**PARTS & SERVICE
NEWS**

REF NO.	AT01209
DATE	Nov. 13, 2001
(C)	Page 1 of 4

SUBJECT: TO MODIFY COMMON RAIL FLOW DAMPER ON WA500-3 WITH SA6D140E-3

PURPOSE: To modify common rail flow damper of SA6D140E-3 engine for WA500-3 to prevent a possibility of flow damper crack and fuel leakage.

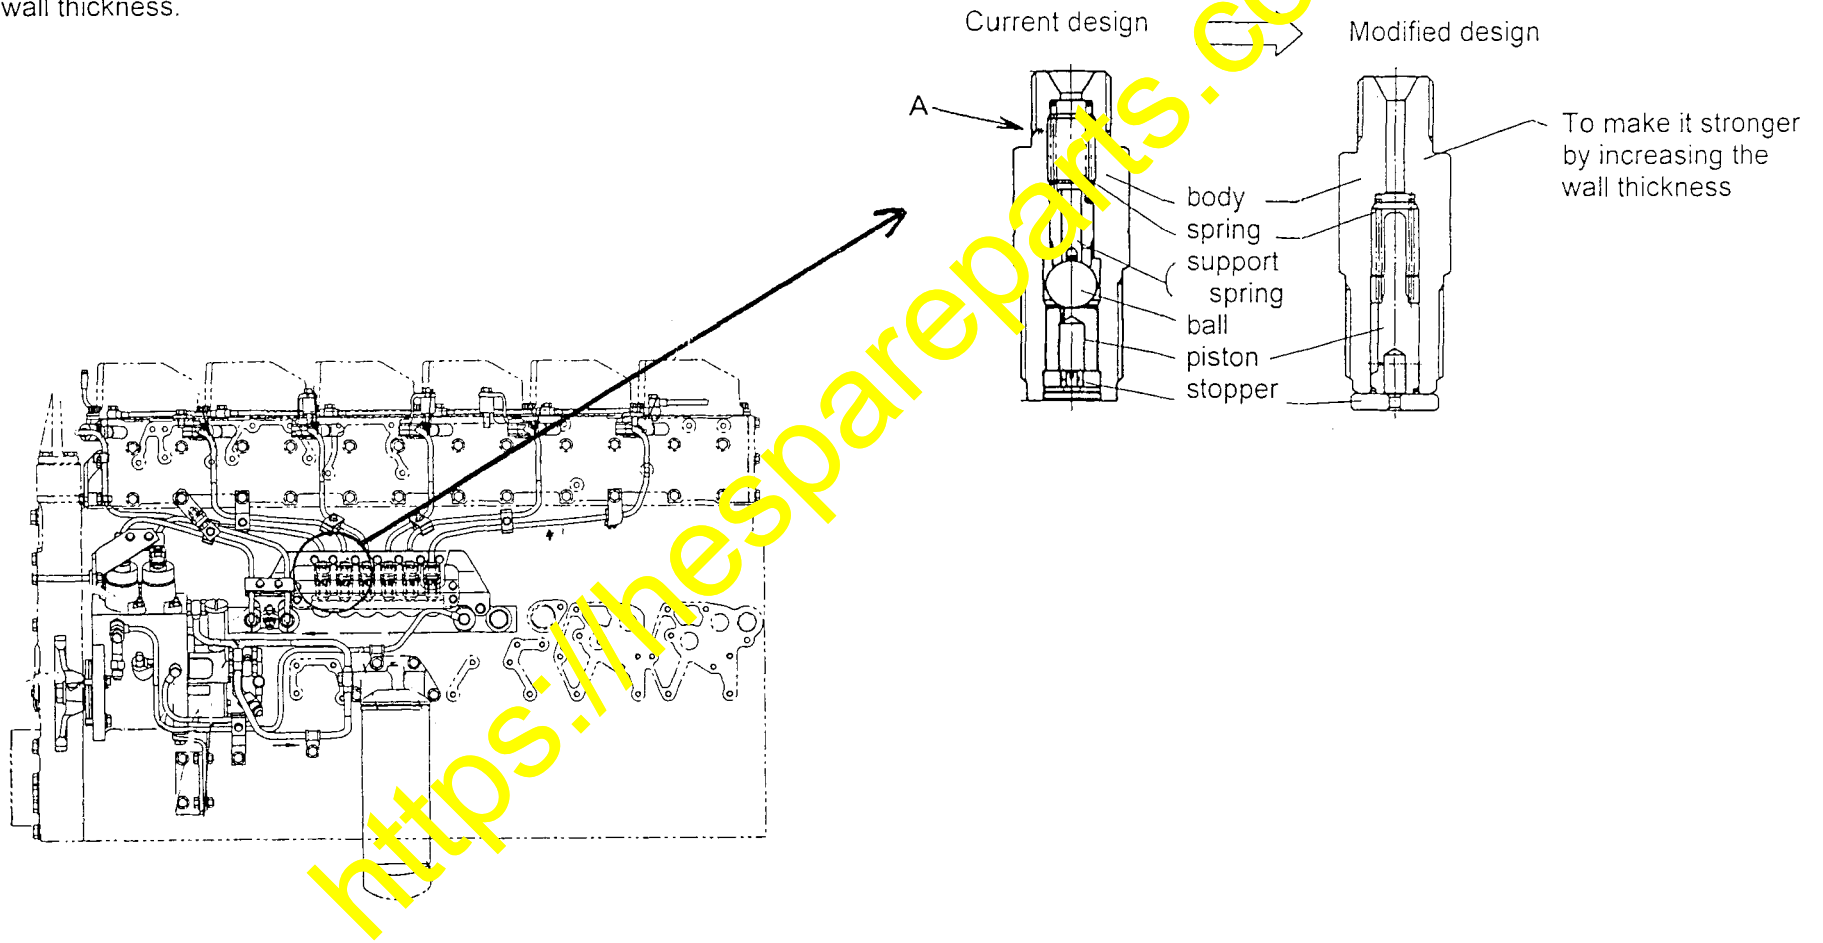
(2) In the case of new common rail installation like this, it may take longer period for restarting the engine, because of no fuel existing in the common rail.

It will be effective to improve this situation, if you fill fuel into the common rail by hand priming action at supply pump, before you tighten the fuel injection pipe sleeve nuts between common rail and injectors.

This treatment makes restarting lead time shorter.
